SERIAL: HNP-11-079

SHEARON HARRIS NUCLEAR POWER PLANT, UNIT NO. 1
DOCKET NO. 50-400/RENEWED LICENSE NO. NPF-63
RESPONSE TO REQUEST FOR ADDITIONAL INFORMATION
REGARDING MEASUREMENT UNCERTAINTY RECAPTURE
POWER UPRATE LICENSE AMENDMENT REQUEST

SHEARON HARRIS NUCLEAR POWER PLANT, UNIT NO. 1
DOCKET NO. 50-400/RENEWED LICENSE NO. NPF-63
RESPONSE TO REQUEST FOR ADDITIONAL INFORMATION REGARDING
MEASUREMENT UNCERTAINTY RECAPTURE POWER UPRATE
LICENSE AMENDMENT REQUEST

Figure 1. MVAR Capability and Generator Nameplate Requirement Example

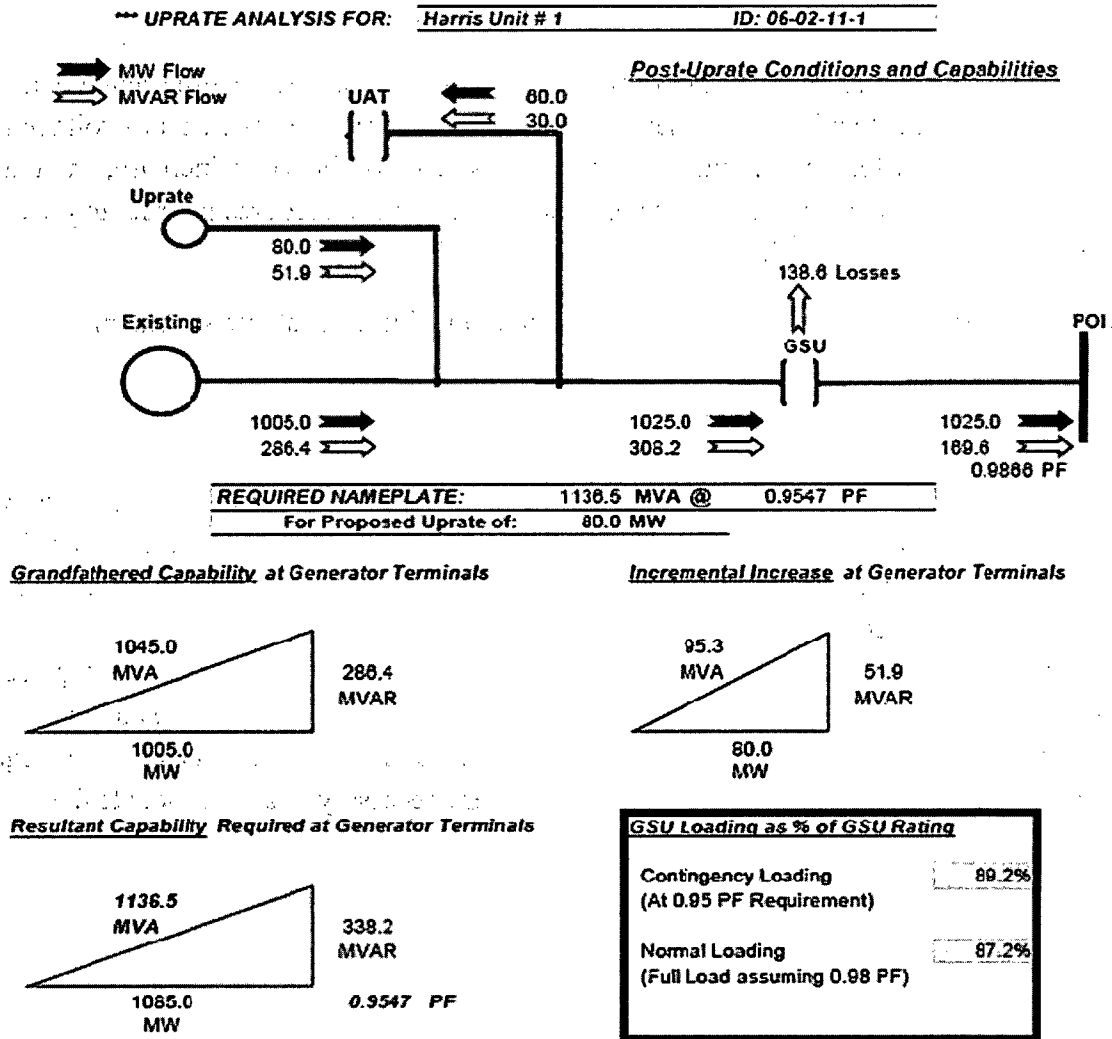
In Enclosure 2, Section V.1.D, "Grid Stability – Large Generator Interconnect Power Factor Requirement," the licensee stated that for a 66 Mega Watt electric (MWe) increase on HNP Unit 1, a generator nameplate rating of 1155 Mega Volt Ampere at 0.94 Power factor lagging was required.

Provide a summary of the calculation that confirms that the capability of the replacement main generator will bound the MVAs Reactive requirement corresponding to the 66 MWe increase.

PEC Transmission Planning determines the MVAR requirement for generation additions, including MW increases of existing generators. The requirement is that the generation must be capable of delivering the additional MW output to the point of interconnection (POI) at a 0.95 lagging power factor. For an existing generating unit which is being uprated, this requirement applies only to the MW increase. The existing MW output of the unit is grandfathered at the unit's present MVAR capability or a MVAR capability equivalent to 0.95 lagging power factor at the POI, whichever is less. This information is used to determine what the required generator MVA/Power Factor nameplate must be to meet the MVAR capability requirement. Figure 1 below illustrates how this was done for the HNP MUR power uprate 66 MW increase. The *Grandfathered Capability* is shown as a power triangle for the original generator, rated at 1045 MVA. Using the 1045 MVA and the maximum gross MW output prior to uprate (1005 MW) yields a grandfathered MVAR capability of 286.4 MVAR. By agreement between HNP and Transmission Planning, an *Incremental Increase* of 80 MW was assumed to allow some margin over the proposed 66 MW increase. This 80 MW was used only for purposes of calculating the MVAR requirement and generator nameplate requirement. Using the 80 MW increase, an additional 51.9 MVAR would be required at the generator terminals. This value takes into account the additional losses in the main (step up) transformer, referred to as *GSU* in Figure 1, due to the increase. The *Resultant Capability* triangle is the geometric sum of the *Grandfathered Capability* and *Incremental Increase* triangles. From the *Resultant Capability* triangle, a generator nameplate of 1136.5 MVA at 0.9547 power factor is required. Based on this, the actual installed generator nameplate was chosen to be 1155 MVA at 0.94 power factor. As can be seen in the figure, this does not mean that the entire MW output of the unit conforms to the 0.95 lagging power factor at the POI requirement.

LEFM Electrical Load Description

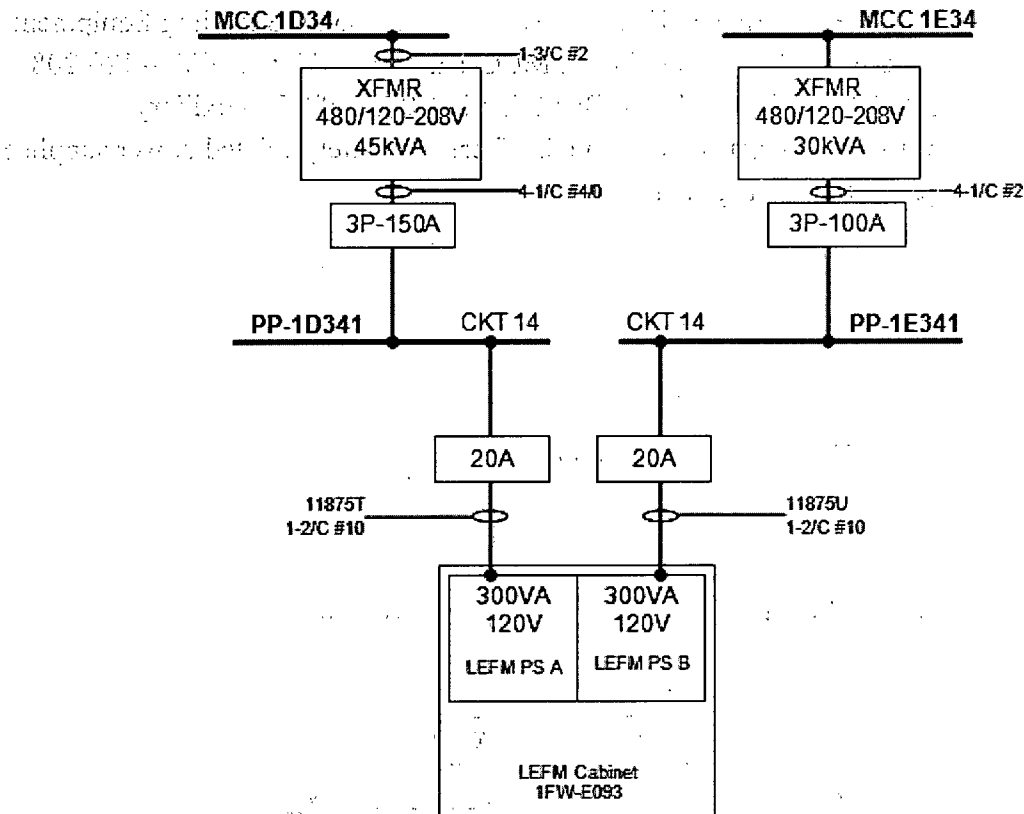
Provide a discussion on the auxiliary power requirement for the Cameron Leading Edge Flow Meter CheckPlus System, such as direct current or AC power requirements, and its loading impact on the associated safety-related or non-safety-related bus.

The LEFM CheckPlus System consists of an electronic cabinet installed in the Secondary Sampling Equipment Enclosure located in the Turbine Building, and measurement spool pieces installed in each of the three main feedwater lines. Two 120 VAC, single phase, 60 Hz power sources are supplied to the LEFM CheckPlus system.

The LEFM Check Plus system is not required to function during a postulated accident or event. Therefore, the system uses non-safety power sources, and emergency diesel generator loading is unaffected. There are two independent measurement systems (A and B) in one cabinet. Each measurement system has its own independent power supply. Each power supply is fed by a separate circuit from a separate power source to maintain independence.
